# Planning, Design and Access Statement (PDAS) Addendum

32 Kingsend, Ruislip HA4 7DA

November 2023

Planning Application 9894/APP/2022/3871 was made on the 21/12/2022 for the demolition of the existing property at 32 Kingsend and the construction of seven purpose-built apartments. On the 12/04/2023 Application 9894/APP/2022/3871 was refused planning permission, after being referred to the Planning Committee Meeting.

**Drawing 3.1.3.1b** above shows the newly proposed floor plan, all basement rooms being non-habitable

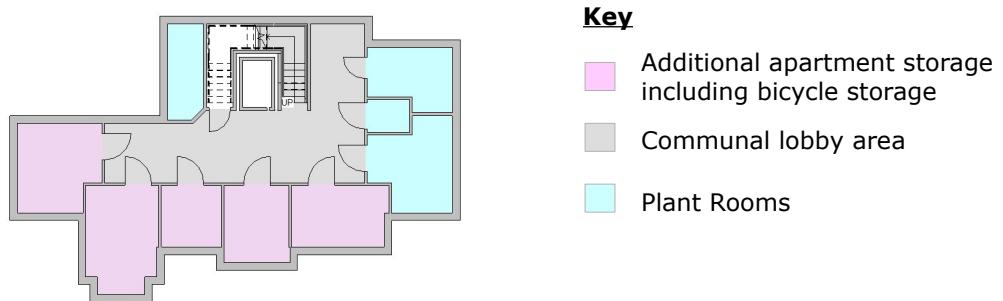
The two basement apartments contained in the previous scheme have been removed from the revised scheme, the basement now only contains ancillary spaces to provide storage facilities and plant rooms as shown in the drawing below.

**Drawings 3.1.3.1.c** opposite shows the area of the rear garden previously proposed be excavated to accommodate the basement dwellings and gardens.

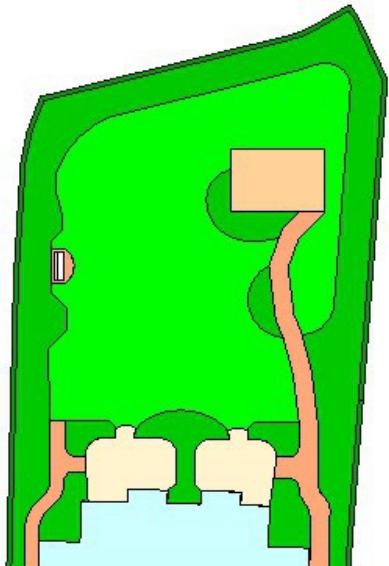
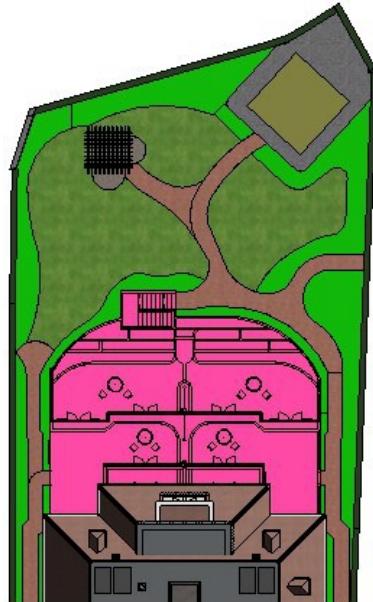
The previously proposed design of the development contained basement apartments and associated lower ground patio and garden areas that required a further twelve (12) metres of the rear garden to be excavated, as shown by the drawing opposite.

The revised design, shown opposite, no longer contains basement apartments or their associated patios and gardens.

**Drawings 3.1.3.2a** opposite shows the cuboid nature of the previous proposal designed with QAR in mind.

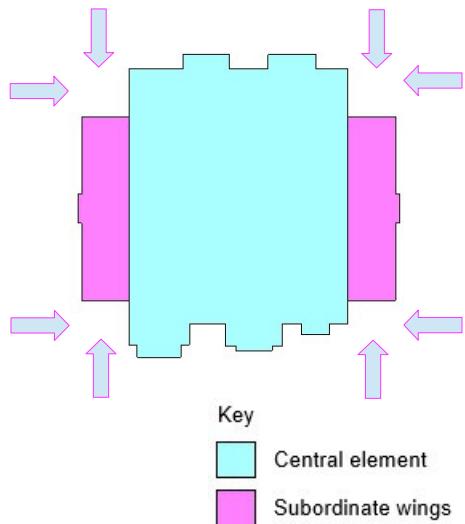
The shape of the previous proposal's footprint, in keeping with the QAR architectural style suggested by LBH in the pre-app, was essentially that of a symmetric, monolithic cuboid, as shown in the drawings opposite.

By changing the architectural style from QAR to Arts and Crafts as now suggested by LBH in the Officer's Report, the constraints of QAR can now be removed, and instead of the previous symmetrical and monolithic footprint, a more visually interesting, asymmetric, geometric form can be utilised. Accordingly, the revised design is now formed from a central element, flanked by two much smaller subordinate wings, one either side, as shown in the drawing opposite.

**Drawing 3.1.4d** above shows the proposed development's location on the plot

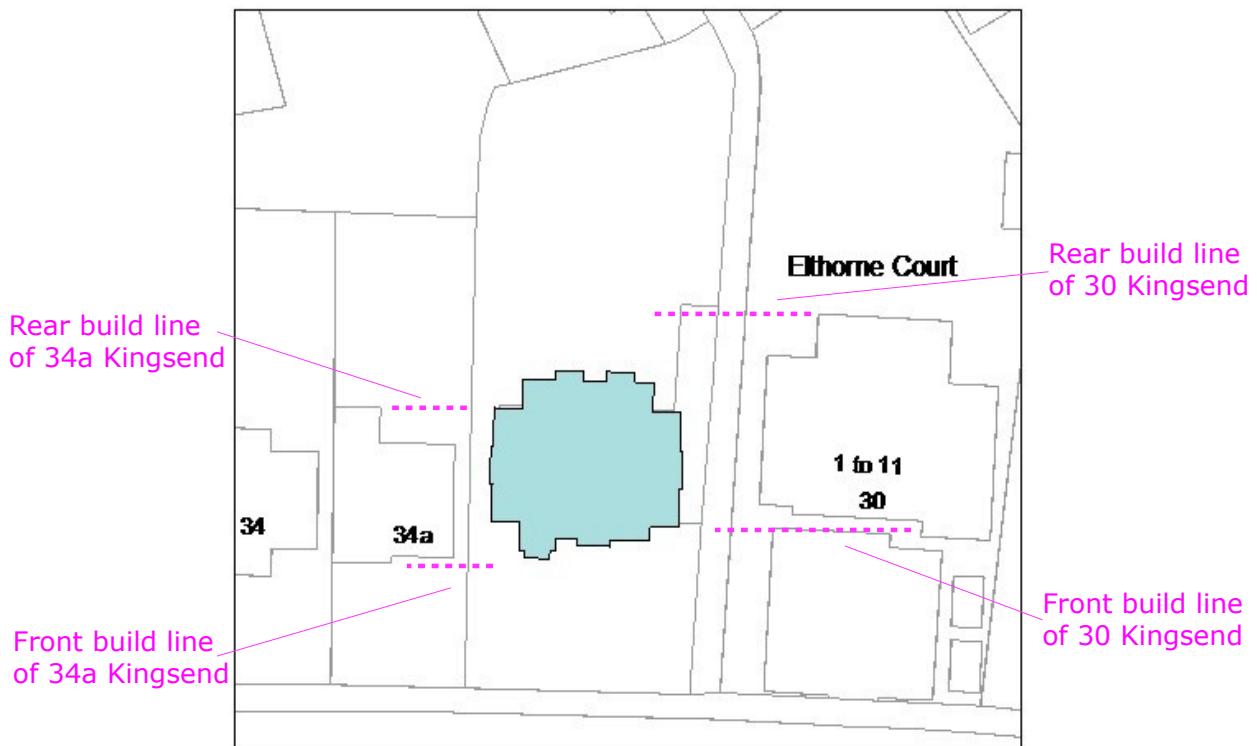
The revised positioning of the development on the plot continues to provide more than adequate clearance both sides of the property, as shown by the drawing below.

The drawing also shows the front and rear build lines of its immediate neighbours and demonstrates that the proposed development is positioned such that it cannot be reasonably be described as creating any containment, neither actual or even perceived.

**Drawing 3.1.4f** above shows the proposed development's compliance with a notional build line directly between 34a and 30 Kingsend.

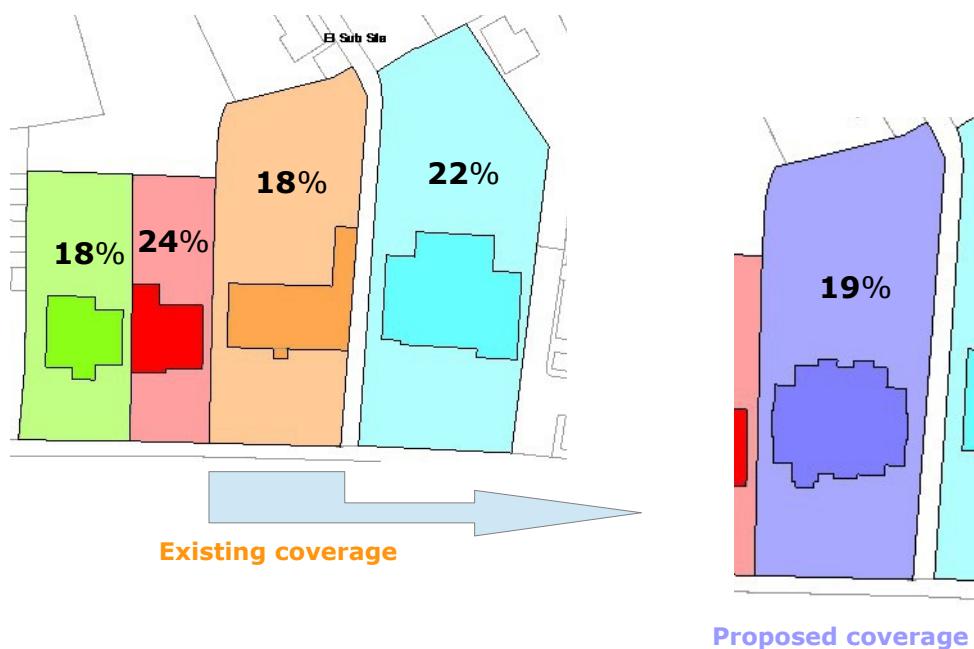
The revised positioning of the proposed development on the plot also conforms with a notional build line directly between 34a and 30 Kingsend, as shown in the drawing below.

The above drawing demonstrates that the revised proposed development is now optimally positioned in the plot, complying with build lines and sight lines and can no longer be reasonably described as causing perceived enclosure.

**Drawing 3.1.6a** above shows the roof now comprising of multiple elements for aesthetics purposes and to ensure minimal massing

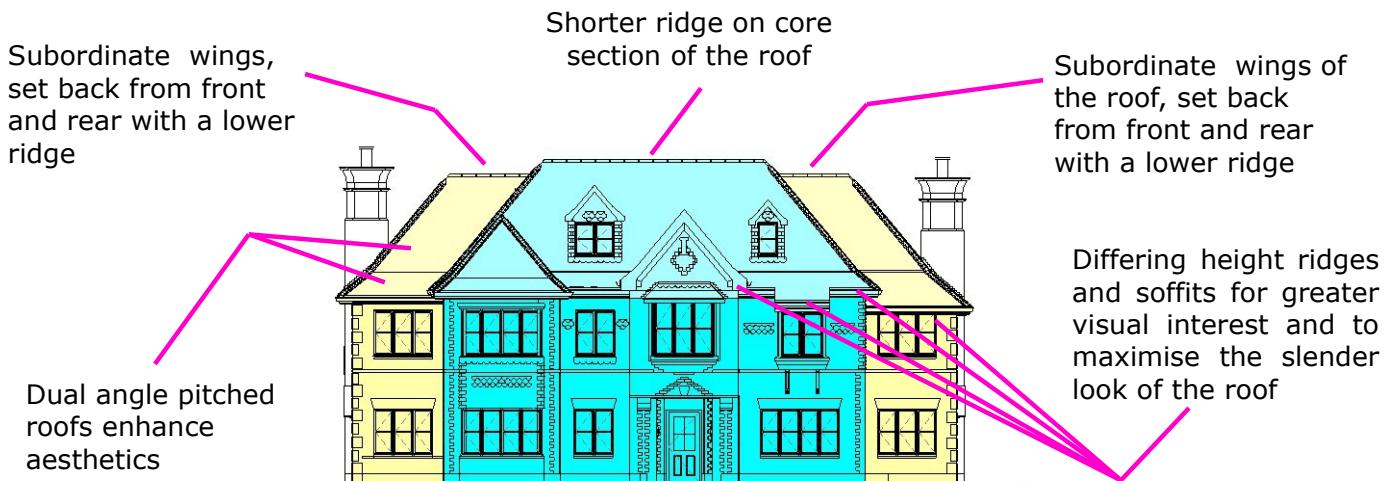
Changing the architectural style of the proposed development from Queen Anne Revival (QAR) to Arts and Crafts, (as detailed in Section 3.1.2), has provided the flexibility to vastly increase the visual interest of the roof's geometric form.

The spirit of the intention of policy DMHD 1 has been acknowledged and addressed by the redesigned roof. The revised roof design changes the previously monolithic roof of the initial QAR design to an Arts and Crafts, more complex and visually interesting form which minimises the impression of a crown roof whilst still enabling the roof space to be utilised as a dwelling.

**Drawing 3.1.8c** above shows the replacement and compensatory planting proposed, with a net gain of four (+4) additional trees.

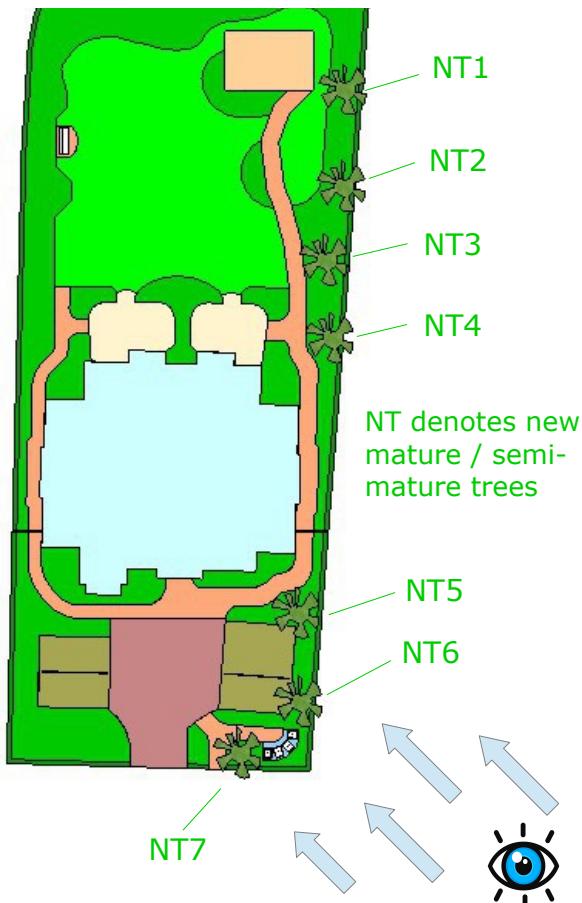
In response to these comments, the revised design has sought where possible to retain existing mature trees. In addition, the landscape and planting strategy has been revised so that the scheme will deliver an immediate positive visual impact from the public realm. These improvements will be achieved by removal of the existing single-storey garage element that forms the boundary to the public footpath and planting of seven (7) new mature and semi-mature trees along the eastern boundary.

The replacement and compensatory planting of the seven (7) new mature and semi-mature trees proposed is therefore focussed on the site's south and eastern aspects.

**Drawing 3.1.8.3b** above shows the newly proposed garden plan with the Larch tree (T9) retained.

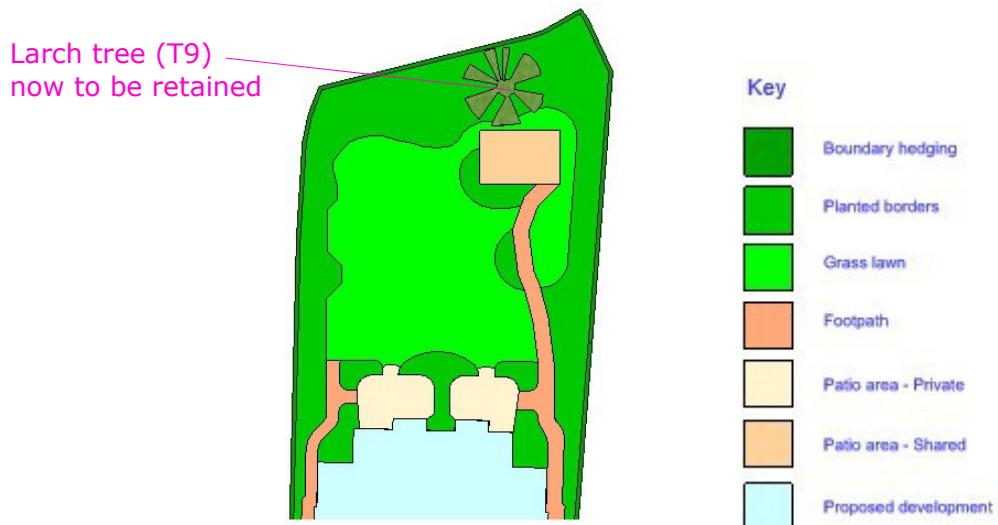
The previous proposal positioned cycle storage in the rear garden, in a position that conflicted with the retention of tree T9 (Larch), as shown in the drawing below.

By relocating the Cycle Store to the basement, as suggested by LBH in the Officer's Report for 9894/APP/2022/3871, the previously proposed store at the end of the rear garden has been removed from the scheme.

**Drawing 3.1.8.4c** above shows the maximum **11%** overlap of the proposed development's footprint with the RPA of Ash tree (T6)

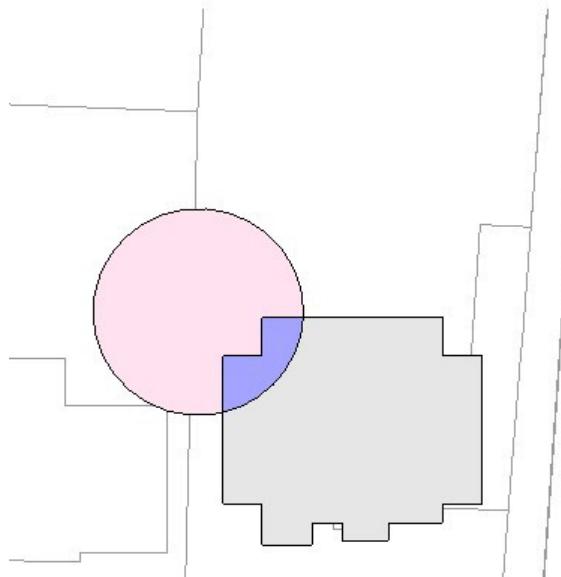
Drawing 3.1.8.4c below shows the overlay of the proposed development's footprint into the RPA of Ash tree (T6). As can be seen from the drawing, the maximum overlay is eleven percent (11%), which is reduced further when displacement of the RPA is factored in owing to the proximity of the existing house and patio. It is therefore fair to contend that it is acceptable for Ash tree (T6) to be retained.

**Drawing 3.2.1b** above shows the currently proposed roof plan with all roof dormers facing either the front or the rear.

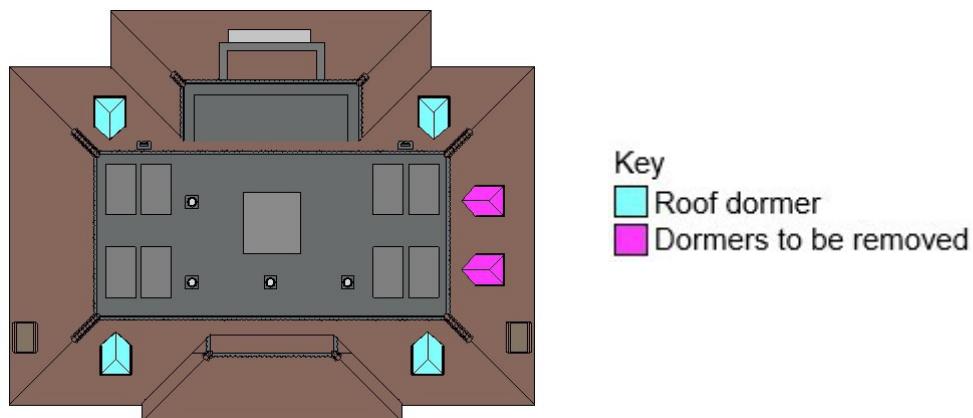
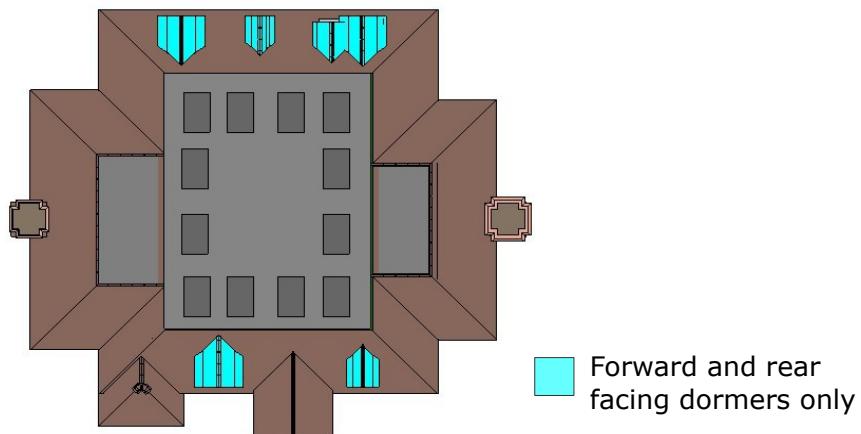
**Drawing 3.2.1a** above shows the previously proposed roof plan with two roof dormers on the right hand side (east elevation).

The side facing roof dormers (formally on the east elevation) have now been removed from the roof design. There are now only forward or rear facing roof dormers to ensure that there is no overlooking or even perceived overlooking.

**Image 3.2.3a** above shows the previously proposed rear elevation with balconies and terraces.

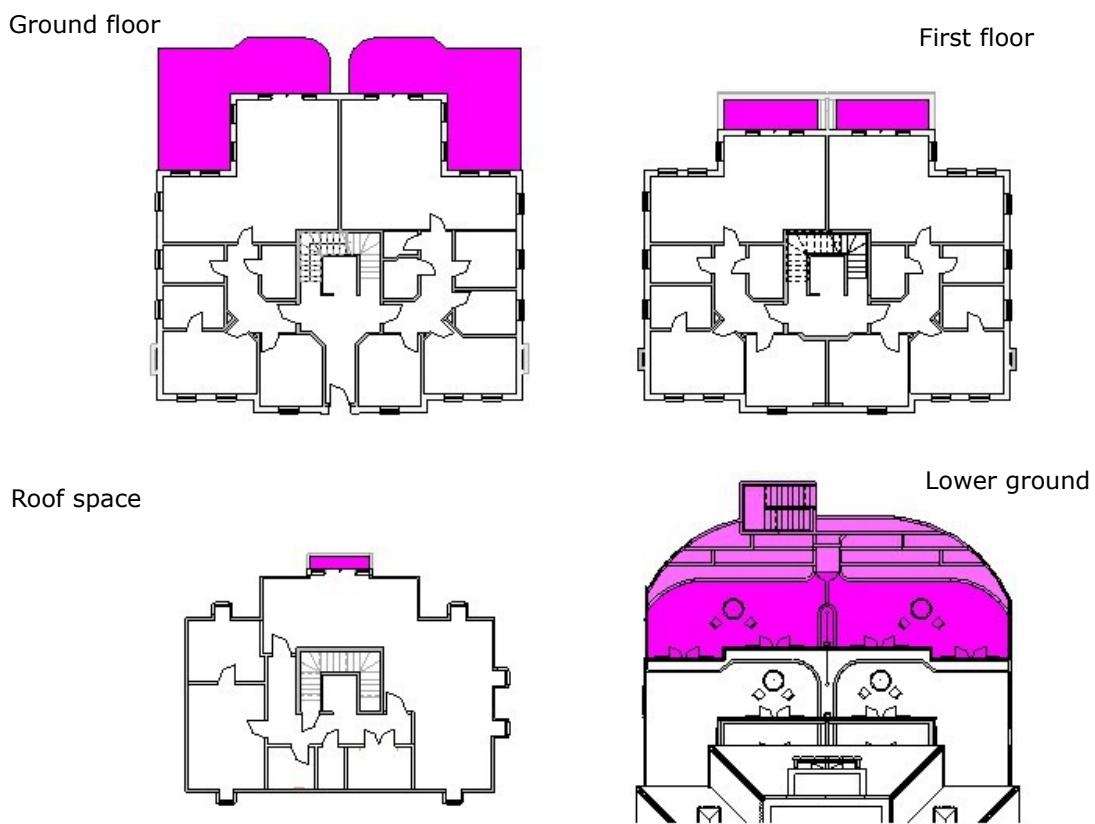
The previous proposal contained five balconies and terraces, (two on the ground floor, two on the first floor and one in the roof space), as well as two patios on the lower ground, as shown by the drawings below.

**Drawing 3.3.1b** above shows the newly proposed floor plan, all basement rooms being non-habitable

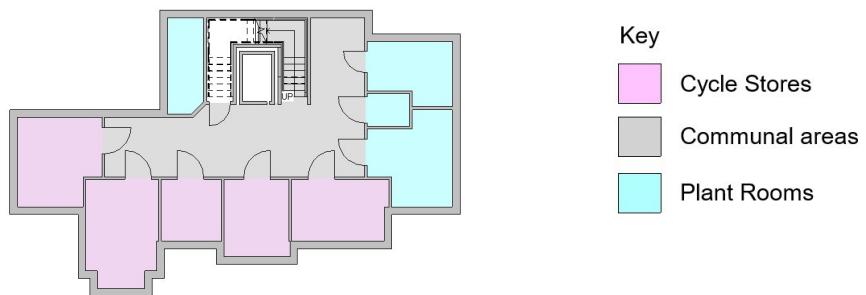
The two basement apartments contained in the previous scheme have been removed from the revised scheme, the basement now only contains ancillary space, such as storage facilities and plant rooms.

**Drawing 3.4.1b** above shows the newly proposed floor plan of the basement with each apartment being allocated a dedicated, private cycle storage facility.

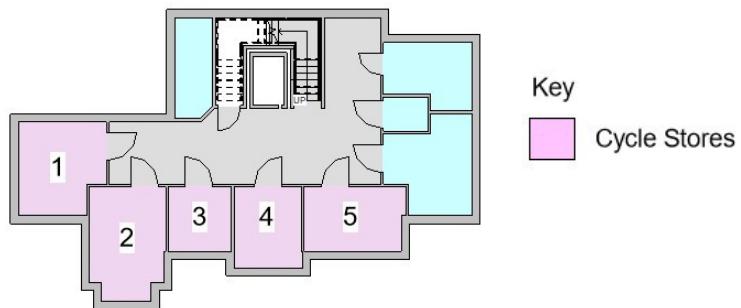
To facilitate this change, a slightly elongated passenger lift car has been designed into the system to ensure easy movement of cycles to and from the Cycle Store.

In the newly proposed scheme, the residents of each apartment now have sole use of their own dedicated, lockable Cycle Store. This will increase security and thereby encourage investment in good quality bicycles, which in turn will help promote cycling as a preferred form of local transport.

**Drawing 3.4.2b** above shows the newly proposed garden plan with the Larch Tree (T9) retained.

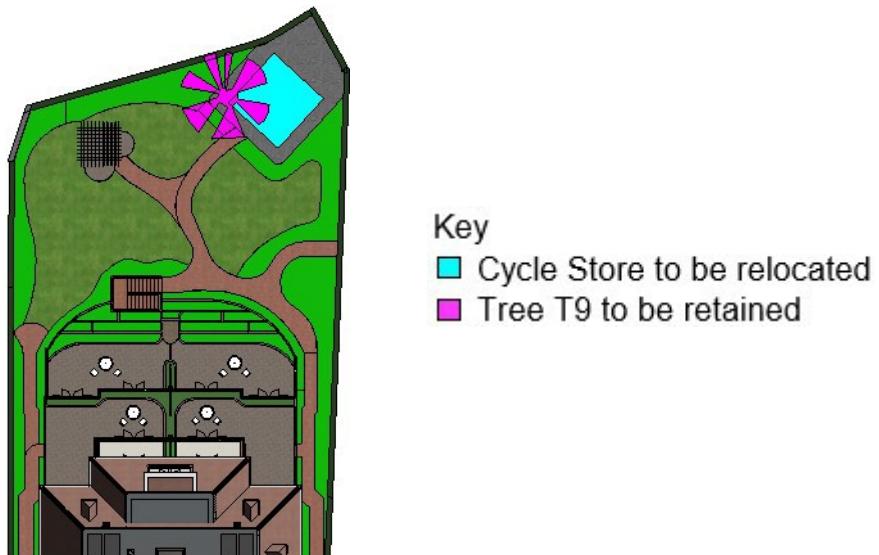
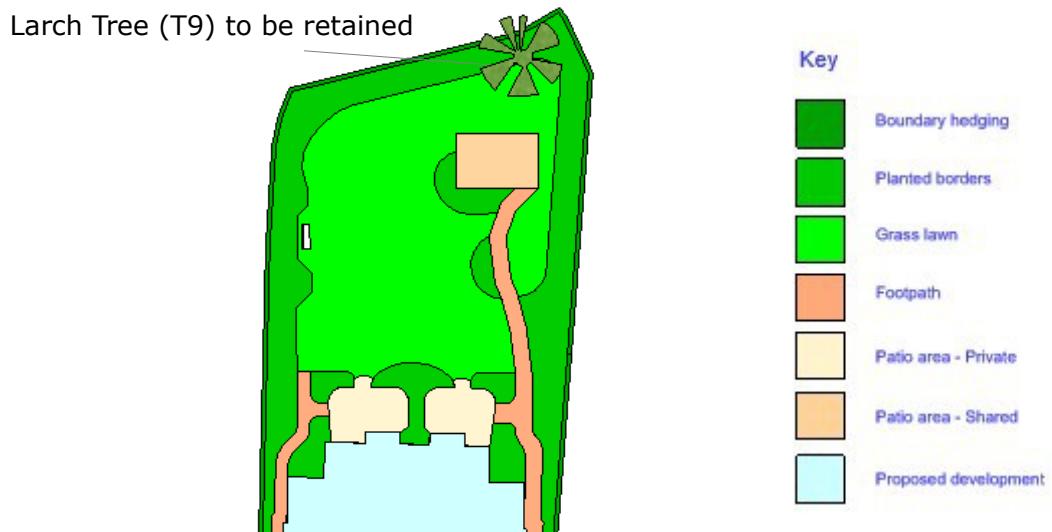
The previous proposal positioned cycle storage in the rear garden, in a position that conflicted with the retention of tree T9 (Larch), as shown in drawing 3.4.2a below.

By moving the Cycle Store to the basement, as suggested by LBH in the Officer's Report for 9894/APP/2022/3871, the previously proposed store at the end of the rear garden has been removed from the scheme.

**Drawing 4.7b** above shows the newly proposed site plan with an equal access parking bay designed into the scheme.

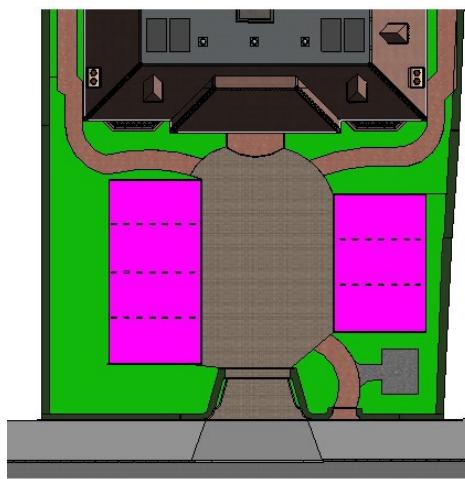
Although the previous proposal contained seven (7) parking bays, no provision was shown on the plans for an equal access parking bay. The previous parking design is shown in Drawing 4.7a below.

The revised parking plan now for only five, rather than seven apartments, incorporates an equal access parking bay. The parking layout conforms to best practice with clear vision splays and allows forward movement when exiting to the carriageway, as shown in Drawing 4.7b below.

Inclusive of this wider, equal access parking bay, there are now four parking bays available to serve the proposed development. All four parking bays will be equipped with active electric vehicle charging points as shown in Drawing 4.7b above.
